**November 14, 2017**  
**BOARD OF COUNTY COMMISSIONERS**  
**ORANGE COUNTY, FLORIDA**  
**ADDENDUM NO. 1 / IFB NO. Y18-714-CC**  
**ORANGE COUNTY FIRE RESCUE HEADQUARTERS COMPUTER ROOM**  
**MODIFICATIONS**

**BID OPENING DATE: November 21, 2017**

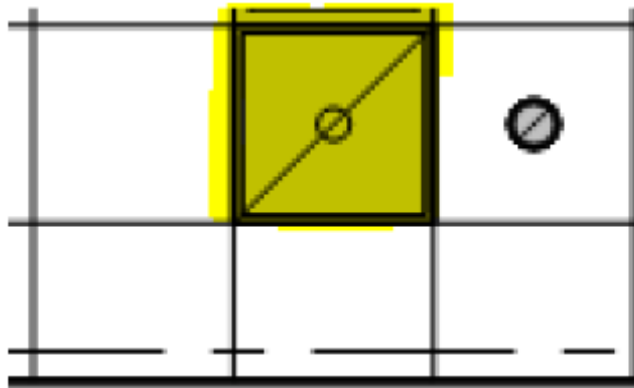
**12. Question:** The Ceiling Legend appears to be incomplete. Please provide a description for the symbol shown below highlighted in yellow:

**Answer:** This is the symbol for a 2x2 recessed light fixture, existing to be removed and reinstalled in new ceiling grid after chilled water piping is installed. Same as symbol below:

**2 x 2 RECESSED LIGHT FIXTURE  
- EXISTING SET IN NEW GRID**

PANEL MDP  
1200A M.C.B. 480V 3ø 4W

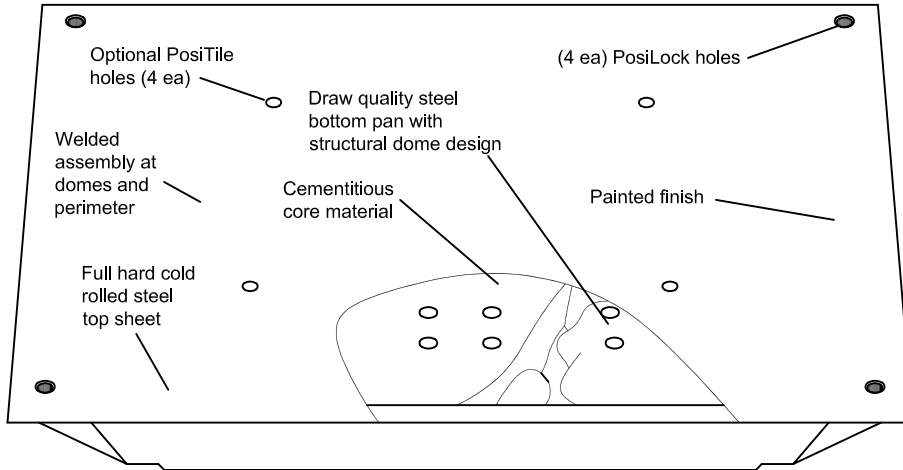
- 3. Clarification:** What is the existing manufacturer for the panel MDP and UPS-DP? Can pictures be provided for MDP and UPS-DP?

**Answer:** See attached photos of MDP and UPS-DP.

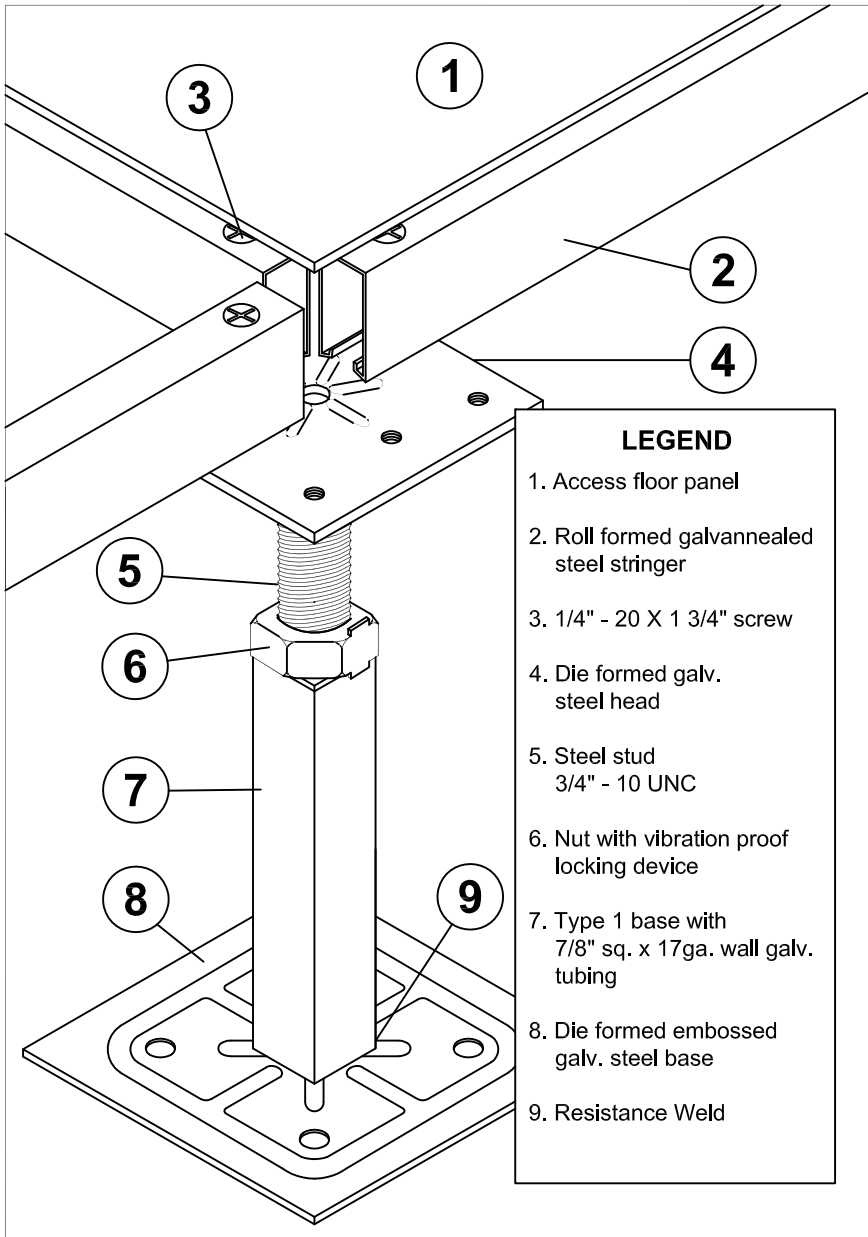
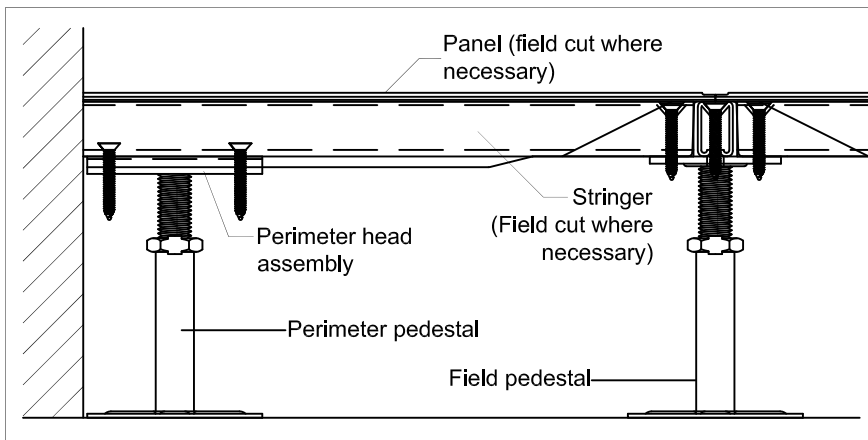
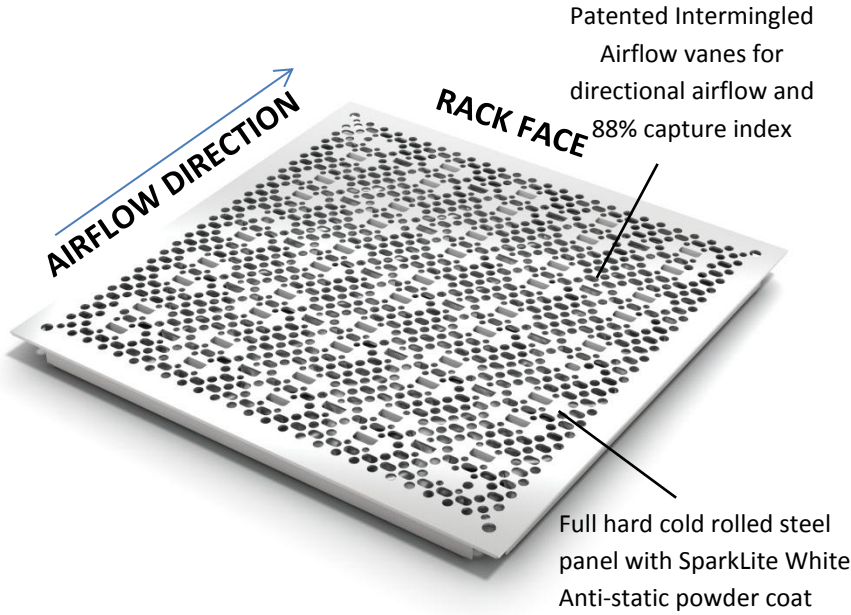
2. **Clarification:** Please clarify the following: Drawing S-201, Detail 1 shows the deck height at 28 feet. This does not match the existing conditions. The existing conditions for the sloped deck range from approx. 10'-15' above the existing ceiling at low point to approx. 18'-20' above the existing ceiling. What provisions are being provided for reaching the deck to secure both the cable tray and the busway? What is the weight rating of the existing raised floor?

095100 is selected and constructed to support the electrical items below the ceiling. See attached information regarding existing raised floor weight rating data.
